**International
Aero Engines**

SERVICE BULLETIN

**NACELLE - EXHAUST - HOIST POINT, TRANSLATING SLEEVE -
MODIFICATION OF**

V2500-NAC-78-0158

Translating Sleeve Hoist Point Modification
Figure 1

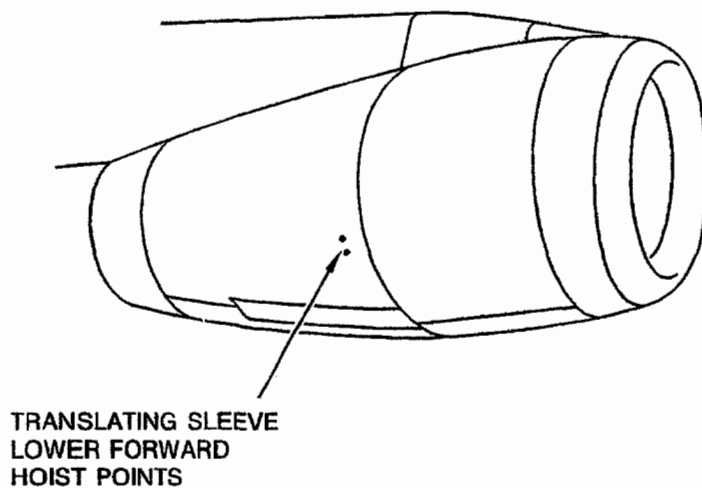
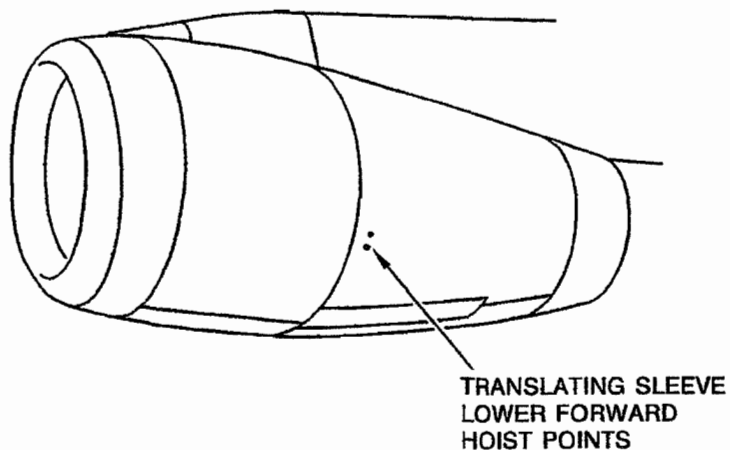
Sealant is put into the lower forward translating sleeve hoist point to prevent vibration of and damage to the floating insert.

- (1) Remove the NAS1081C4A4 setscrew from the hoist point.

- (2) Apply release agent (CoMat 02-158) to the NAS1081C4A4 set screw and install the setscrew in the hoistpoint.

- (3) Mix the sealant (CoMat 08-033). Refer to the manufacturer's instructions.
- (4) Put sealant the space between the body of the hoist point and the floating insert.
- (5) Cure the sealant (CoMat 08-033). Keep the setscrew in the center of the hoist point while the sealant is cured. Refer to the manufacturer's instructions.
